CLOVERLEAF SUBDIVISION
LOCATED IN NE1/4 OF SECTION 23 AND NW1/4 OF SECTION 24,
TOWNSHIP 11 SOUTH, RANGE 67 WEST OF THE 6TH P.M.,
COUNTY OF EL PASO, STATE OF COLORADO
ROADWAY PLANS

EPC STORMWATER REVIEW COMMENTS
IN ORANGE BOXES WITH BLACK TEXT

CLOVERLEAF FILING 2
EL PASO COUNTY, COLORADO
STORM SEWER AND POND PLANS

PUBLIC UTILTY PLAN

SHEET 9 OF 19

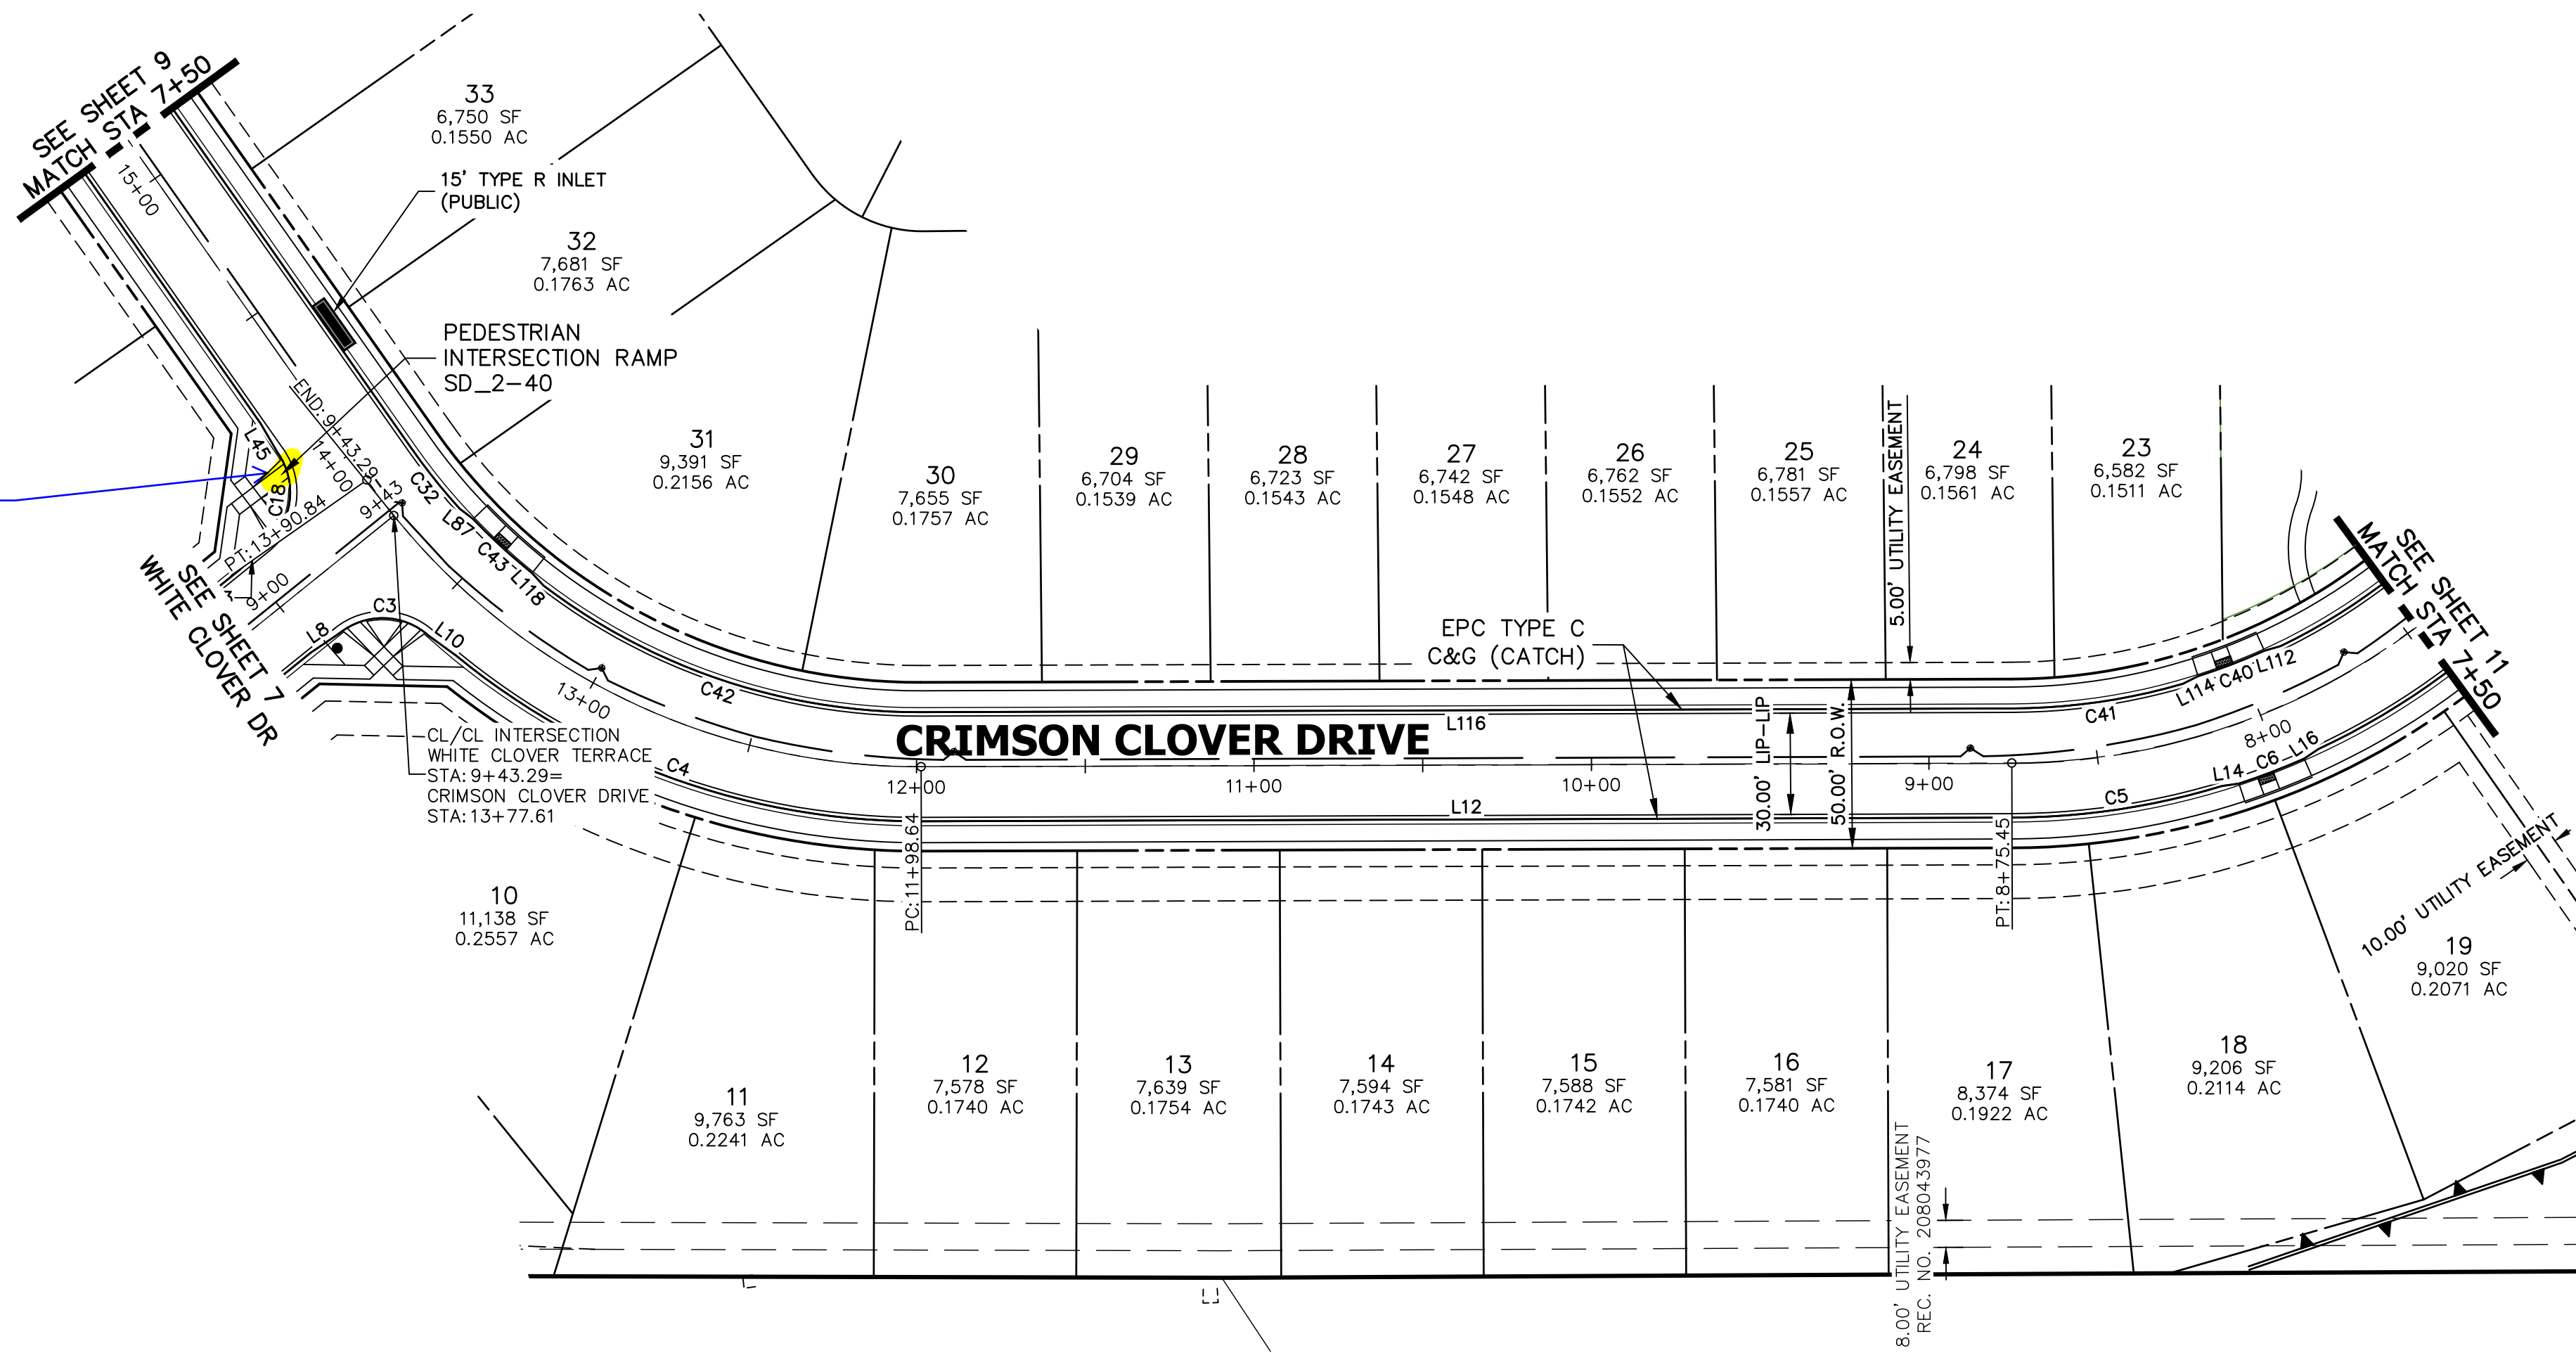
Remove highlighted ramp. One crossing location at T-intersections is sufficient.

SHEET 13 OF 19

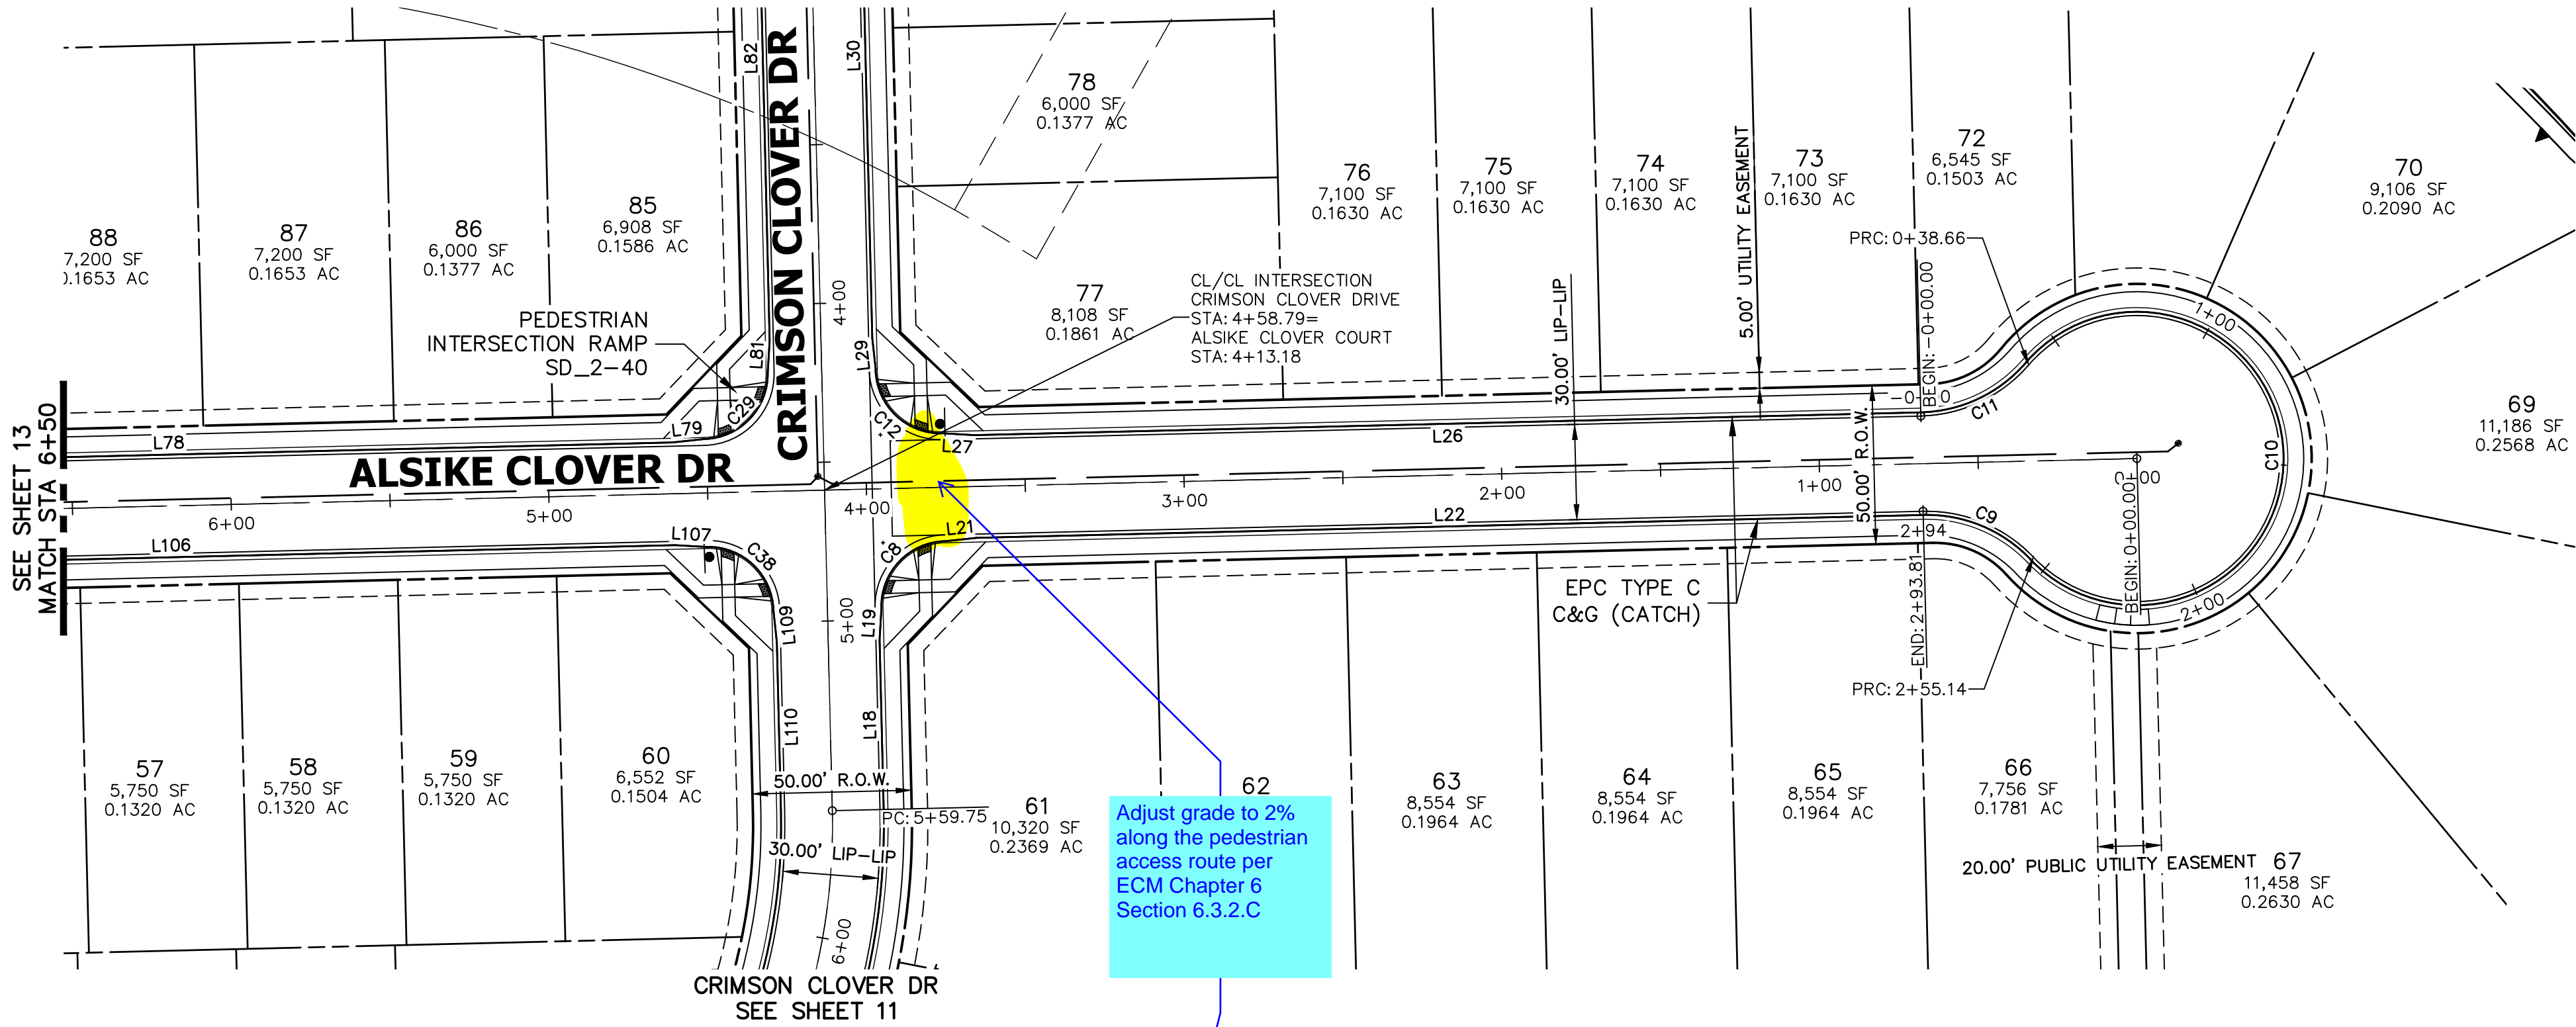
Adjust grade to 2%
along the pedestrian
access route per
ECM Chapter 6
Section 6.3.2.C

CLOVERLEAF SUBDIVISION		ROADWAY PLAN AND PROFILE	SHEET 14 OF 19
JOB NO. 25158.01

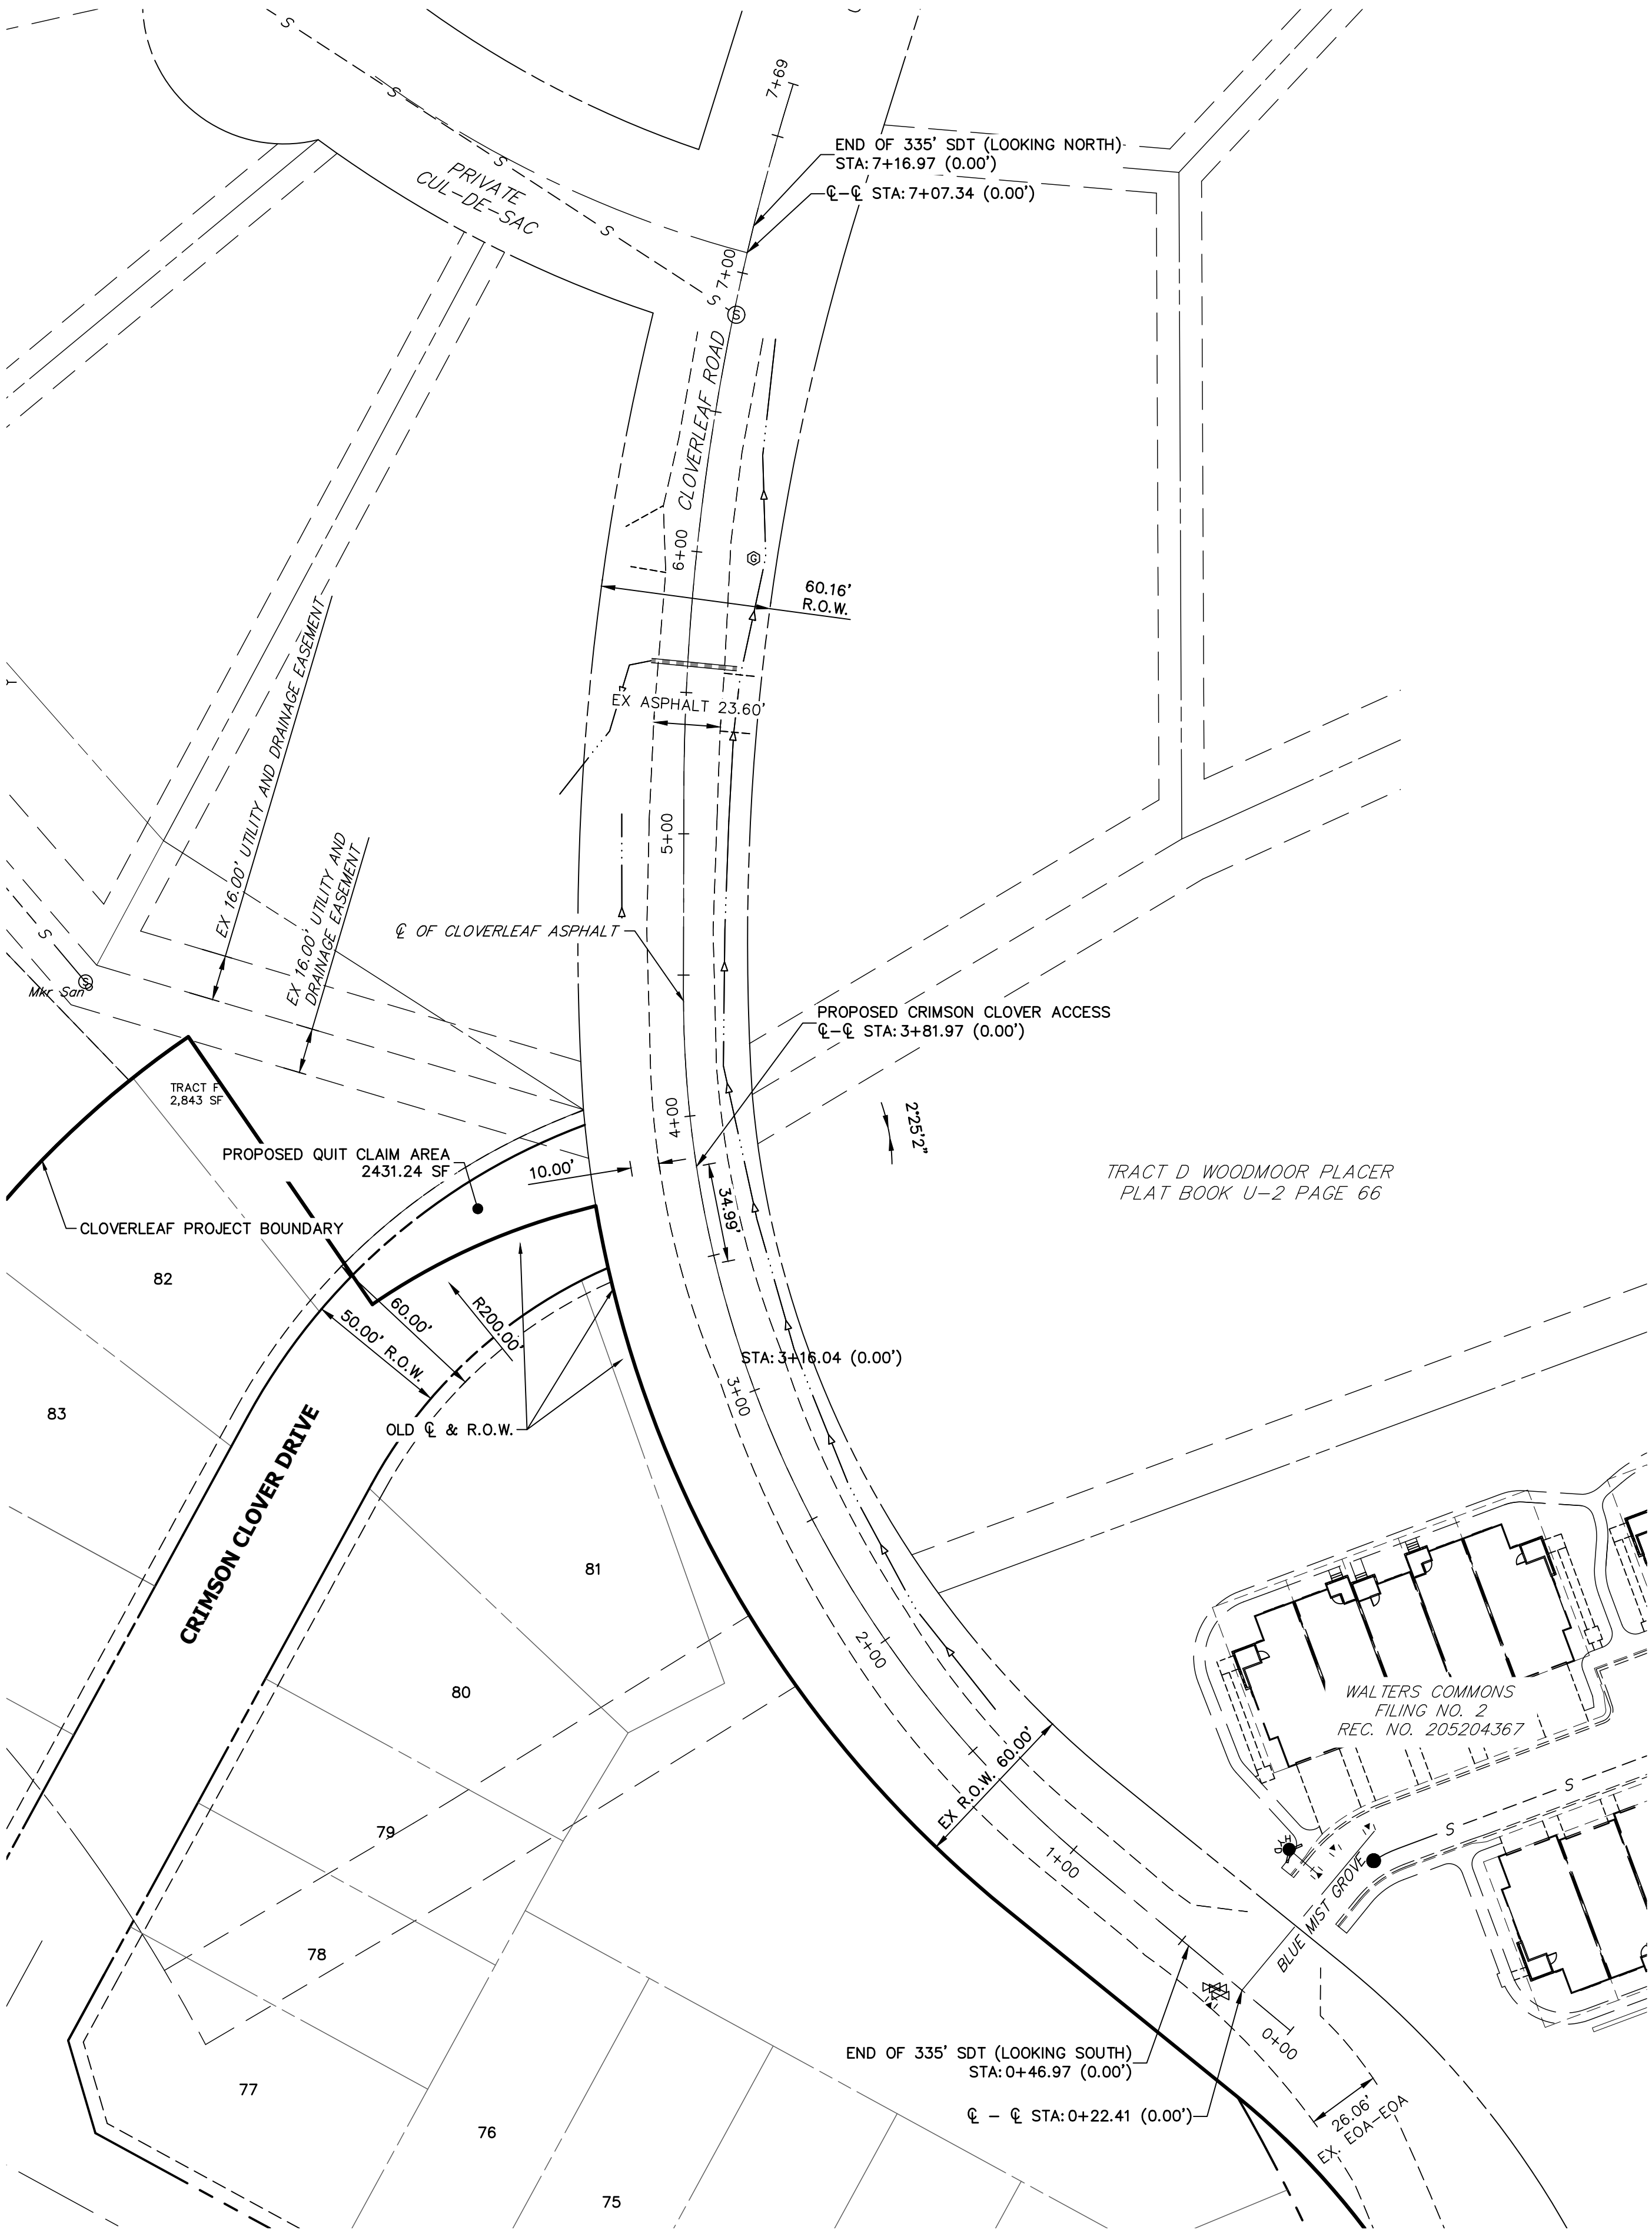
Provide cloverleaf road profile from 0+00 to 7+00.
Show the intersection line of sight on the profile.
